ADDENDUM NO. 1 - OUTLINE AND SUMMARY INFORMATION

Project Name: Reid Hall – Center for Research on Rural Education Renovation

Date: March 24, 2026 **Addendum #:** 1
Project: MSU Reid Hall Center for Research on Rural Education
Project #: 25032
To: All Plan Holders of Record

SHEET
A051

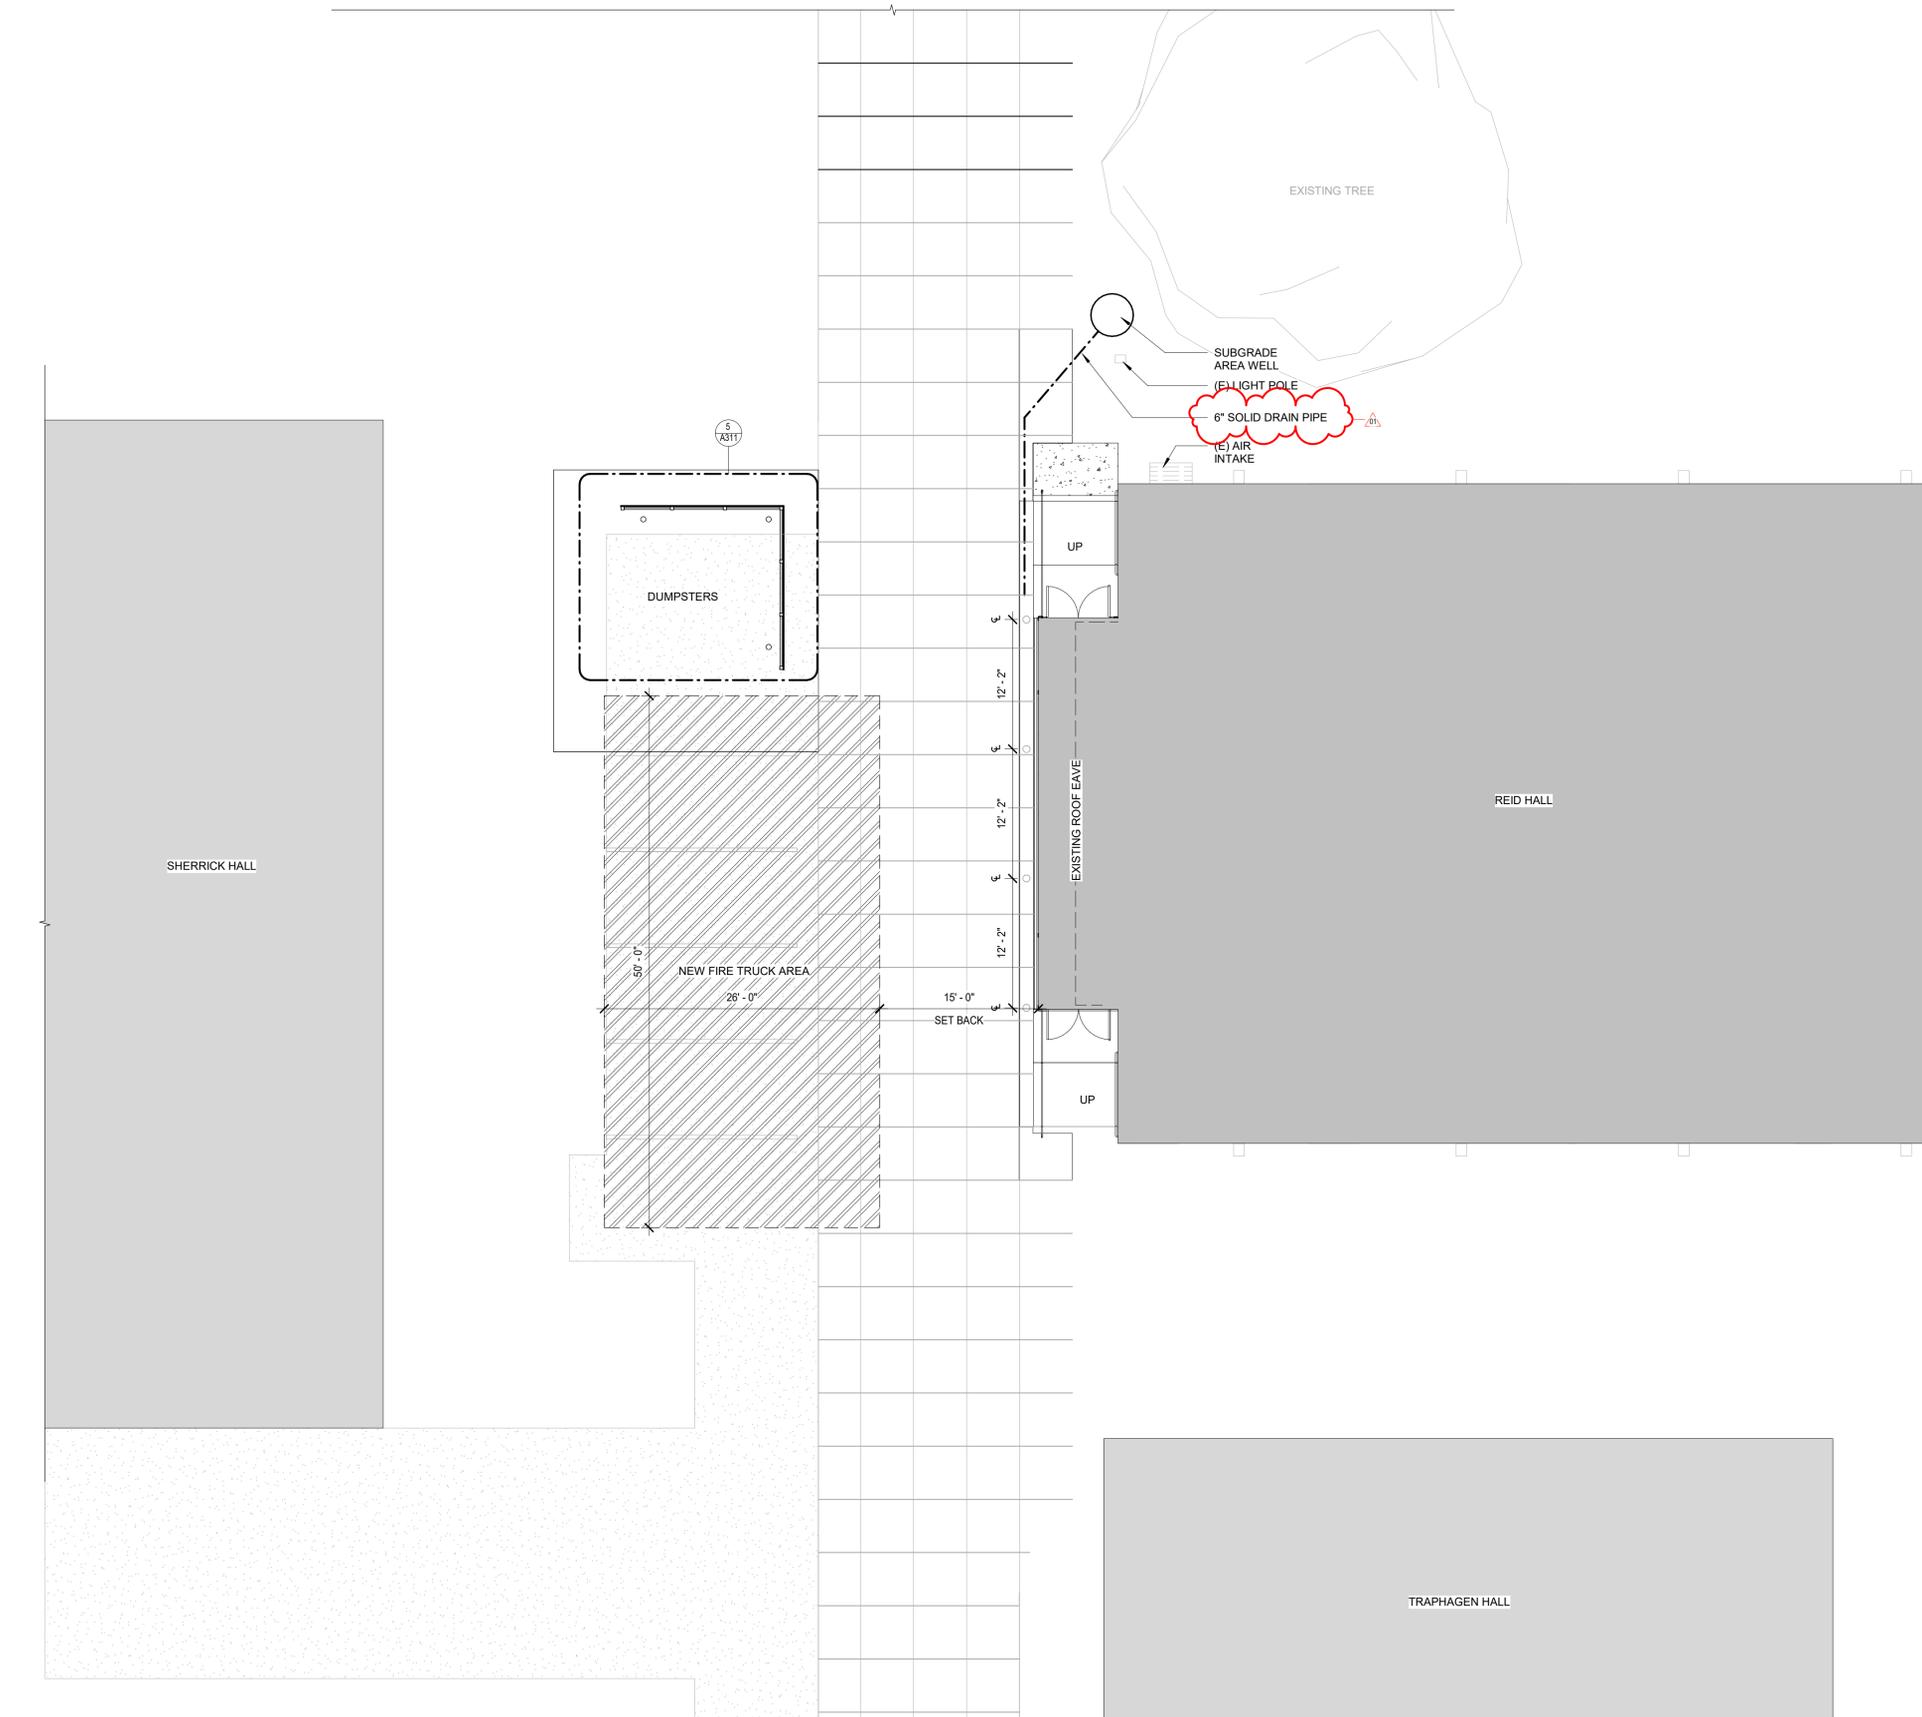
Q2. What size pipe is required for the drainpipe leading to the subgrade area well near existing tree. What slope should be used for the pipe? If the subgrade area well is not existing, can design details and drawings be submitted for installation?

- 1) SHEET A051 – ARCHITECTURAL SITE PLAN – **REPLACE** this sheet in its entirety with the sheet attached. Modifications include;
 - a. **MODIFY:** Drain pipe modified to a 6" solid drainpipe. Detail Attached.

Q2. Pipe size should be 6" and the slope will be field verified based on top of existing tunnel. See detail provided by RPA.

SHEET
A101

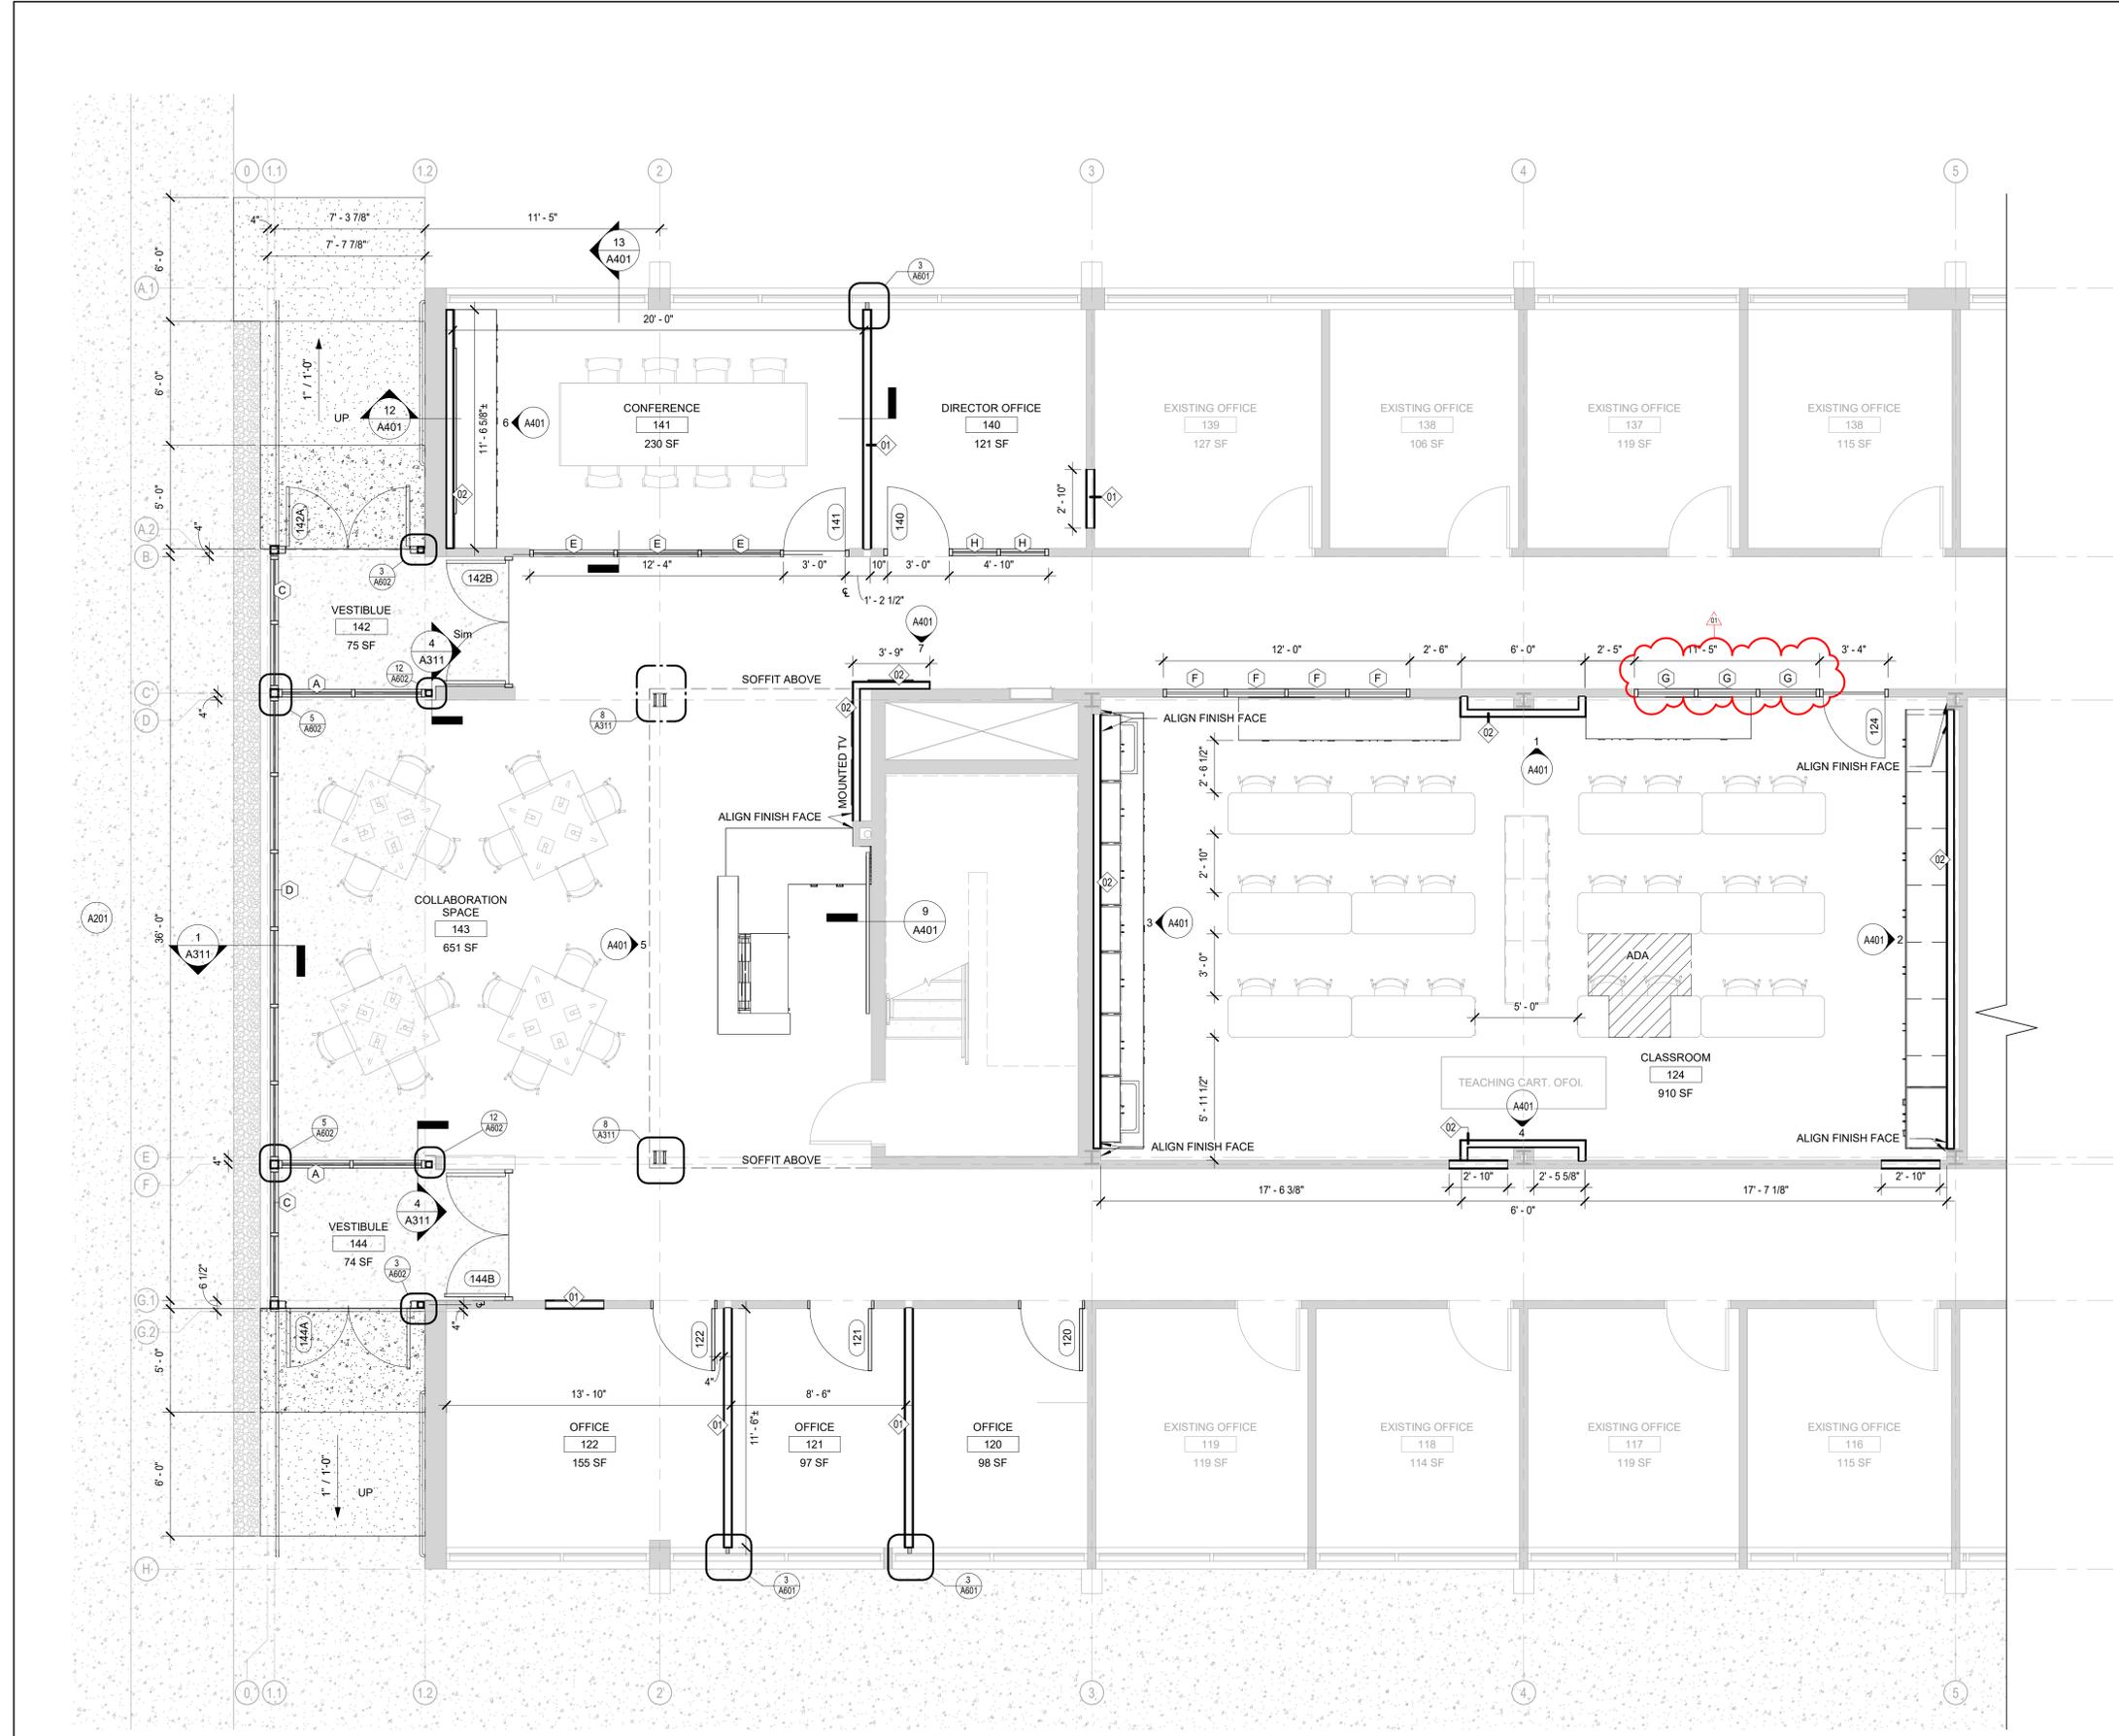
Q5. Window Schedule shows classroom "G" as separate classroom, but there is no "G" type glazing shown on the floor plans. Please clarify where this applies.

- 2) SHEET A101 – OVERALL FLOOR PLANS – **REPLACE** this sheet in its entirety with the sheet attached. Modifications include;
 - a. **MODIFY:** Window tag changed to "G" to match window schedule.

Q5. Please see sheet A101 for updates.

8 DOWNSPOUT DETAIL
1 1/2" = 1'-0"

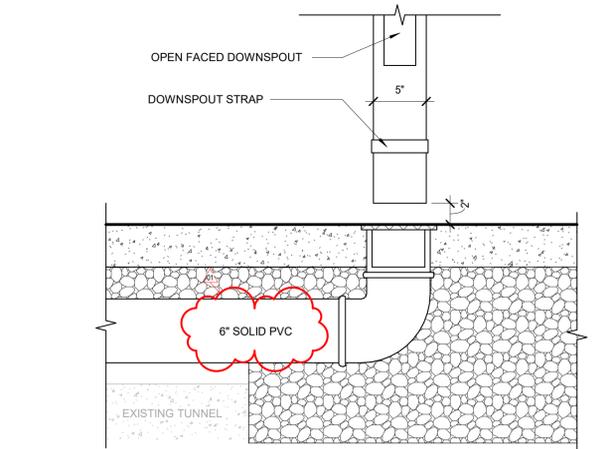
- 3) SHEET A201 – EXTERIOR ELEVATIONS – **REPLACE** this sheet in its entirety with the sheet attached. Modifications include;
 - a. **MODIFY:** Detail 8/201 modified to a 6" solid PVC. Detail Attached.

1 POWER & SPECIAL SYSTEMS REMODEL PLAN
1/4" = 1'-0"

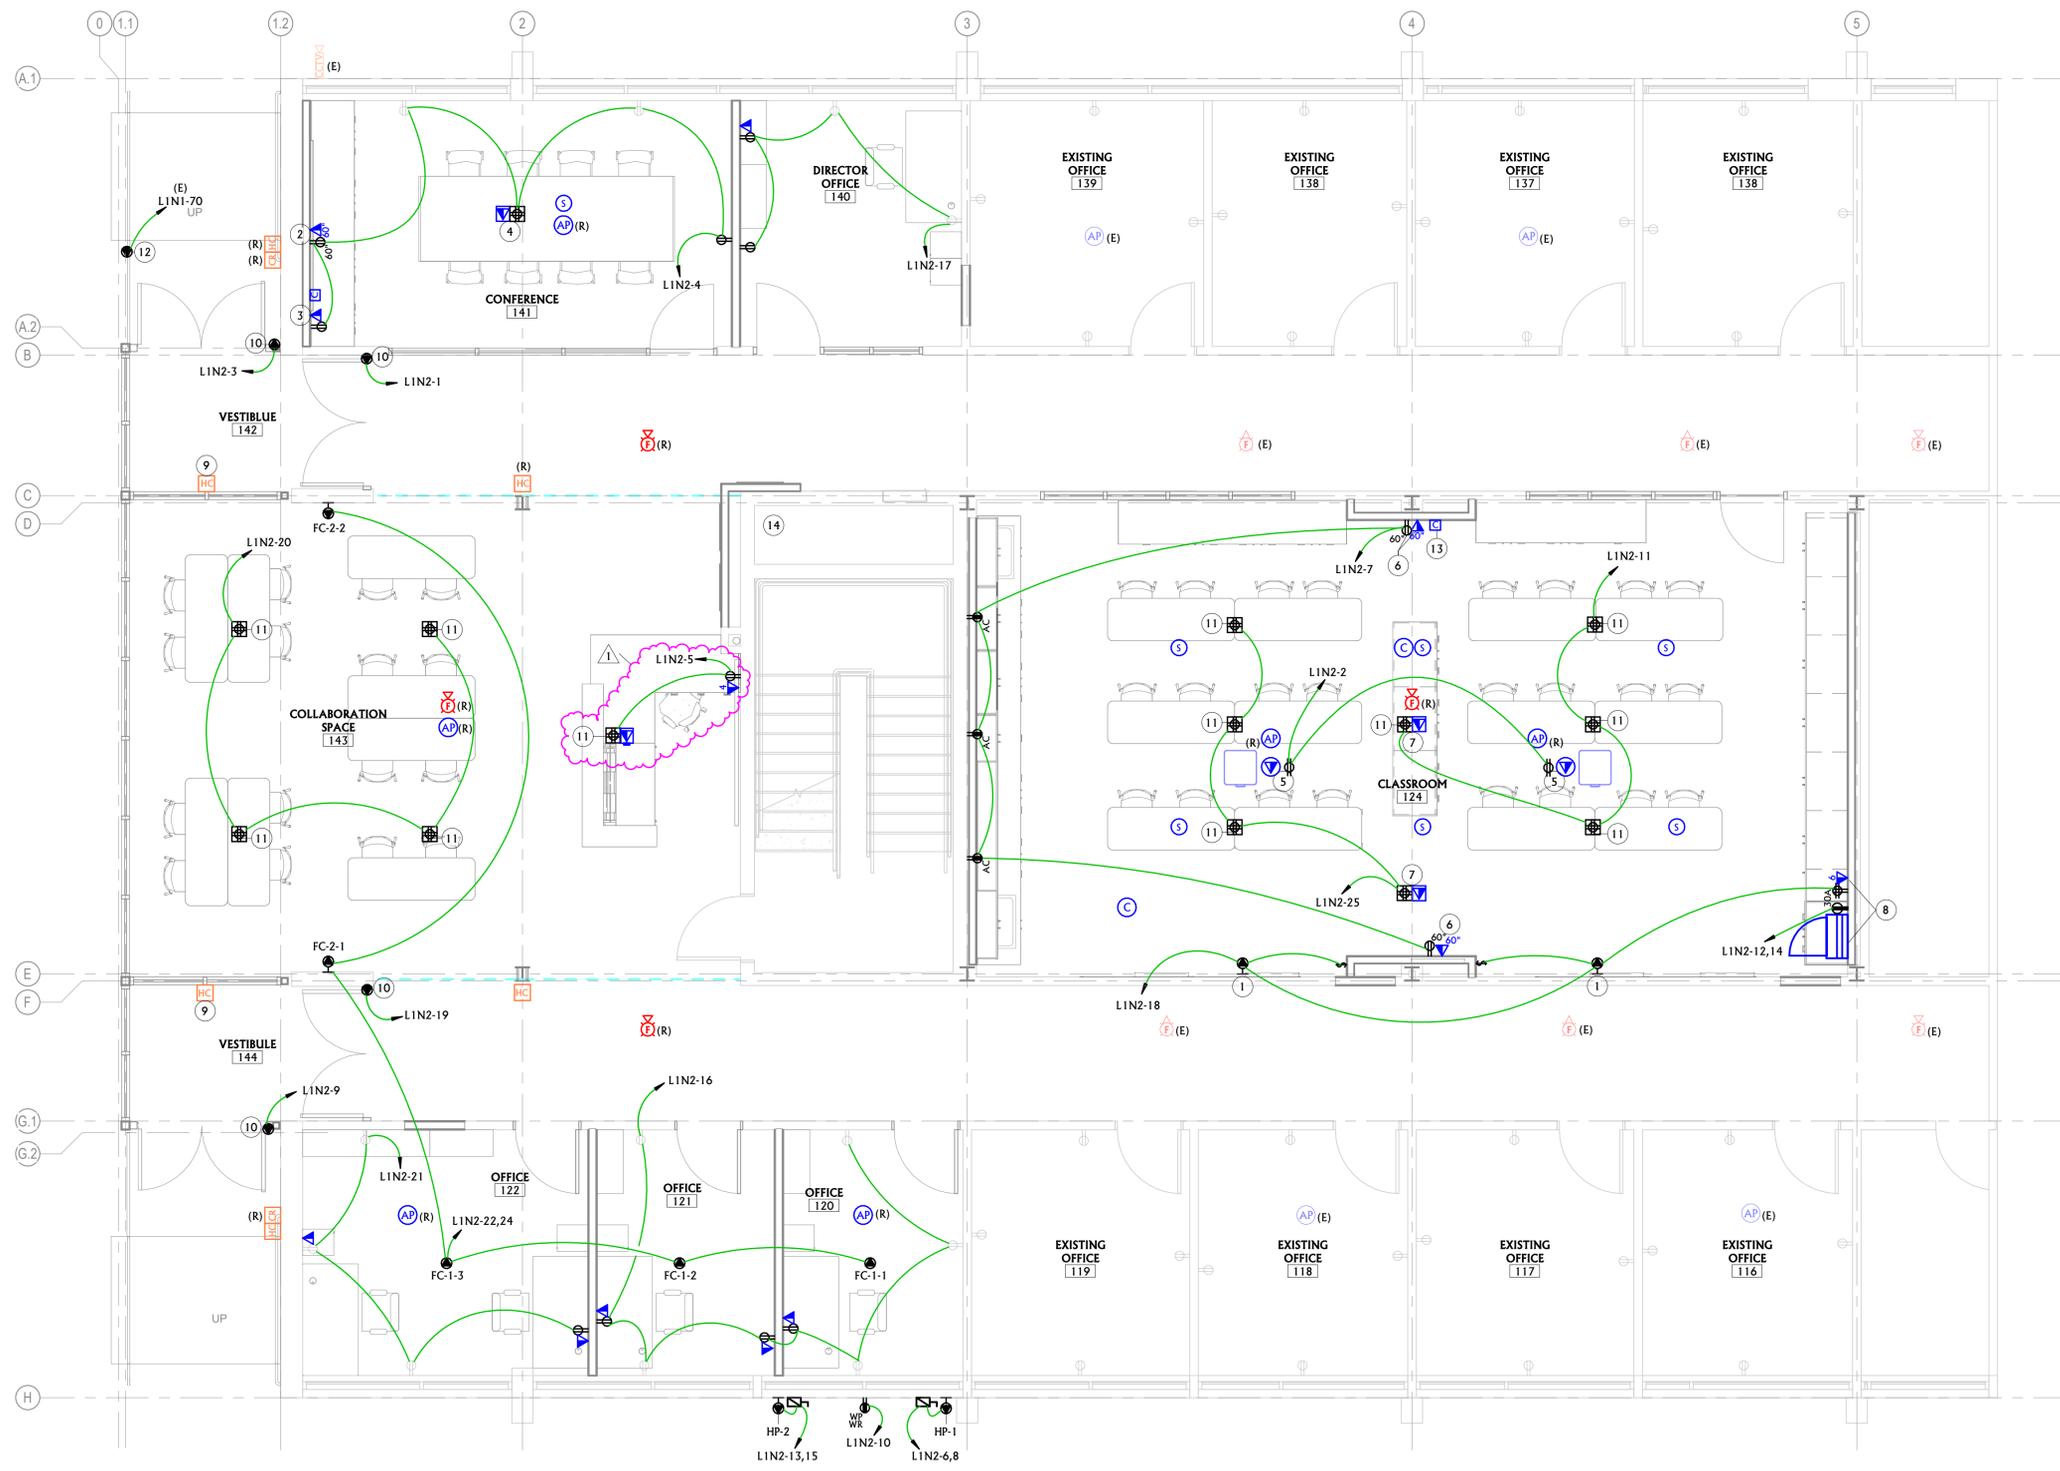
- 4) SHEET E2.0 – POWER & SPECIAL SYSTEMS REMODEL PLAN – **REPLACE** this sheet in its entirety with the sheet attached. Modifications include;
 - a. **ADD:** Floor box and data connection at reception desk in Collaboration space 143. Circuit to LIN2-5. Add keynote 11 to floor box.

- b. **MODIFY:** Power connection to a receptacle in Collaboration Space 143. Remove keynote for modular furniture.
- 5) SHEET E5.0 – ELECTRICAL SCHEDULES – **REPLACE** this sheet in its entirety with the sheet attached. Modifications include;
